Canutillo Middle School Subdivision

City Plan Commission — October 9, 2025

CASE NUMBER/TYPE:	SUSU25-00085 – Major Combination
CASE MANAGER:	Myrna Aguilar, (915) 212-1584, AguilarMP@elpasotexas.gov
PROPERTY OWNER:	Canutillo Independent School District
REPRESENTATIVE:	SLI Engineering, Inc.
LOCATION:	East of Westside Dr. and South of Artcraft Rd.
PROPERTY AREA:	50.31 acres
VESTED RIGHTS STATUS:	Not Vested
PARK FEES:	Park Fees Not Required
EXCEPTIONS/MODIFICATIONS:	Yes, see following section
ZONING DISTRICT(S):	R-F (Ranch Farm)

SUMMARY OF RECOMMENDATION: Staff recommends **APPROVAL** of Canutillo Middle School Subdivision on a Major Combination basis and **DENIAL** of the exceptions request.

Figure B: Developed properties within a quarter mile of proposed subdivision

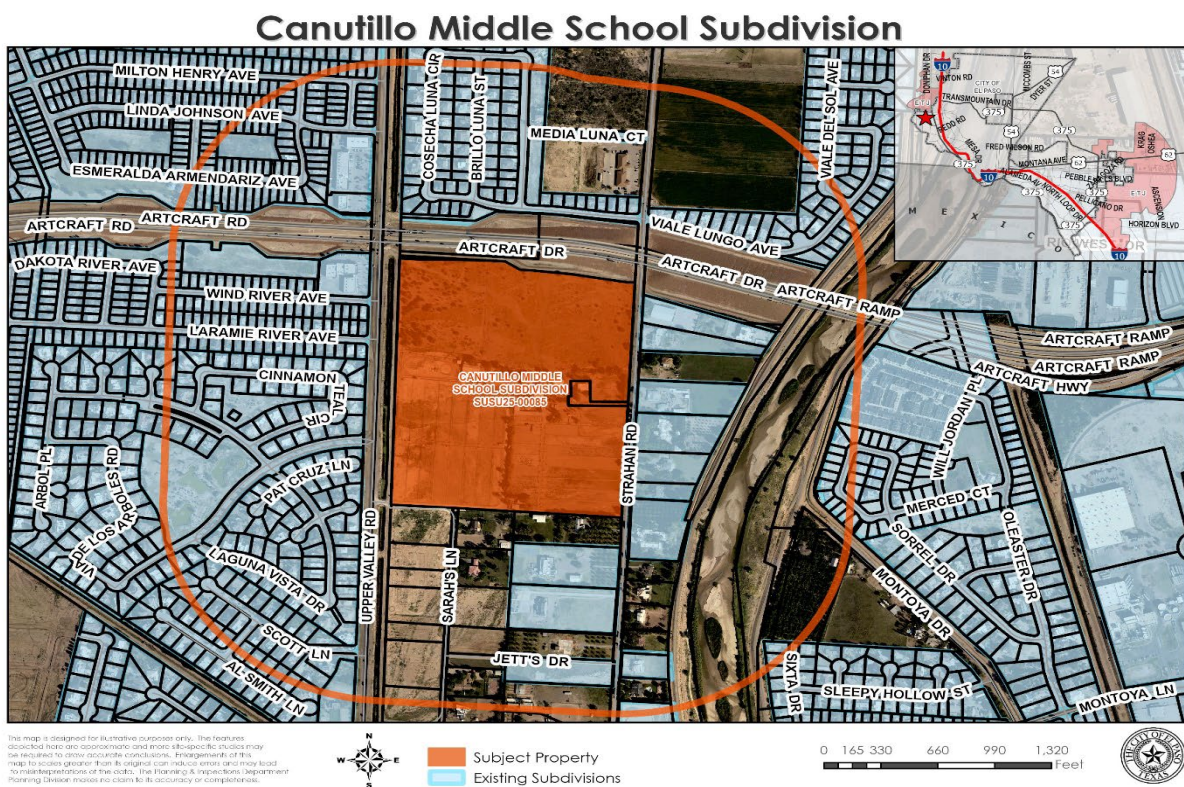
The exception request to waive the required improvements for Strahan Road meets the criteria of already developed and existing street improvements that are in character with the neighborhood.

Although the request for exceptions meets the waiver criteria previously stated, staff recommends **Denial** of the waiver of the construction of sidewalk and additional roadway based on the following analysis:

- This is a corner property that can create the opportunity for initiating sidewalk connectivity in the area.
- Property located at the northeast corner of Artcraft Dr. and Strahan Rd. has already improved proportionate cross-section's sidewalk.
- Sidewalks will provide a safe route for pedestrian and enhance ADA access along Strahan Rd. and the proposed Middle School for Canutillo Independent School District.
